Re: Application for Permit 37-22685 Ground water heat pump and injection

Permit 37-22685 Ground water Heat Pump and Injection

Date: February 23, 2012
To: Allen Merritt
From: Michele Edl
Re: Hagey application review

A HAGEY RESIDENCE - SHALLOW INJECTION WELL SCALE: 1"=5'

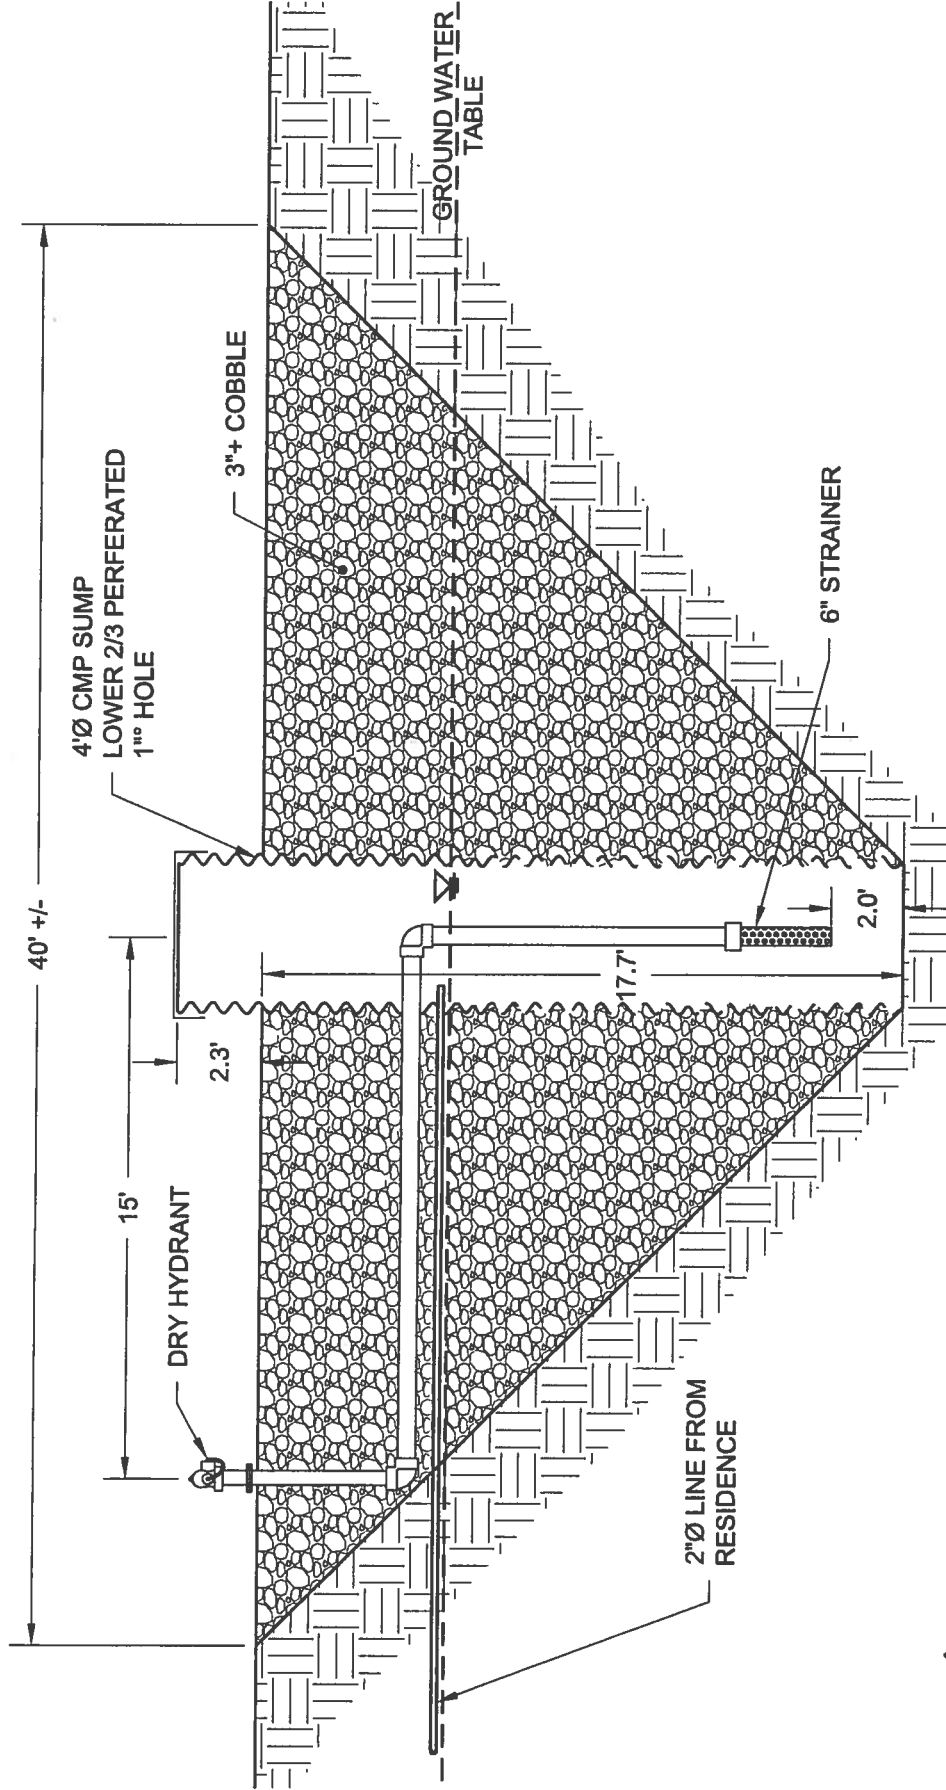
An injection well failure is not uncommon. The heating/cooling discharge can soon reach the capacity and be rejected by the injection well. The examiner for right 21-7567 found and described ponds which had developed on the property from overflow of the injection well. In that case neither the system operator nor I were able to locate well logs for the injection well. Lack of knowledge about the construction or the capability of that irrigation well may have contributed to the misapplication and malfunction as an injection well.

This type of failure will expose ground water to surface conditions and consumptive use. Without a demonstrated understanding of the sumps capacity to accept discharge expected from the heating/cooling system, the applicants run the real risk of installing a system that puts them out of compliance with constraints of the ground water management area.

The effluent injection sump serves to convey the requested 71.8 gpm maximum flow into the shallow aquifer and the sump also serves as the source for water for fire protection, as approved by the Wood River Fire District. I am enclosing a drawing of the proposed heating system disposal and fire protection sump.

- The hydraulic capacity of the re-injection system utilizing the proposed, perforated, 4.0 ft diameter CMP is more than adequate for the 71.8 gpm maximum effluent discharge. The depth to water at the sump has been measured at 5.2 ft below ground level. The estimated seepage area including the 4.0 ft diameter bottom of the CMP plus the clean cobble is approximately 1009 sq feet. The Theiss equation for a partially penetrating well (Bradbury and Rothschild (1985) specific capacity method and Sternburg (1973) partial penetration approach) in very permeable gravel (300 ft/day) shows that, with a conservative surcharge of 2 ft of head on the ground water level, the calculated capacity of the system is 0.22 cfs or 100 gpm. The water level in the CMP could operate at higher than a 2.0 ft surcharge which will increase the calculated infiltration capacity which is nearly linearly with the surcharge level.
